APPLICATION FOR APPROVAL TO USE AN EXISTING ON-SITE WASTEWATER TREATMENT & DISPOSAL SYSTEM

MECKLENBURG COUNTY - GROUNDWATER & WASTEWATER SERVICES
700 N. Tryon St., Suite 211 Charlotte, NC 28202
Phone: (704) 336-5103 Fax: (704) 336-6894

FILE #: 19093

PROPOSED PLOT PLAN

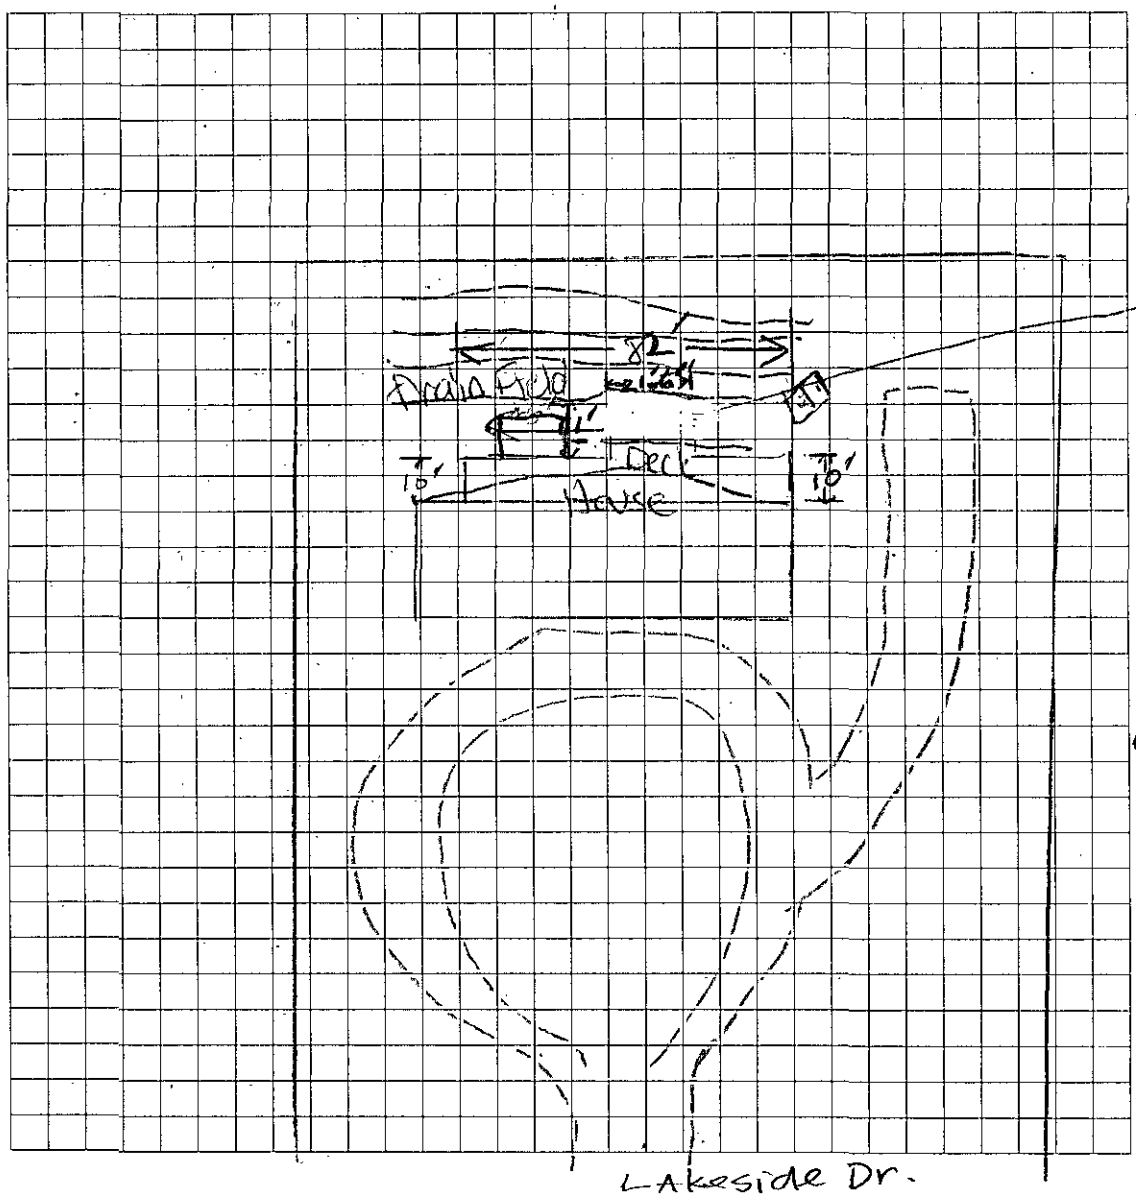
Proposed Deck meets required setbacks off drainfield.
Jeremy Nickel 07-24-2008
EHS Signature — Date

Propose Deck/w gazebo was shifted to meet 5' off drain line. Met builder & Homeowner on site S.A.M.
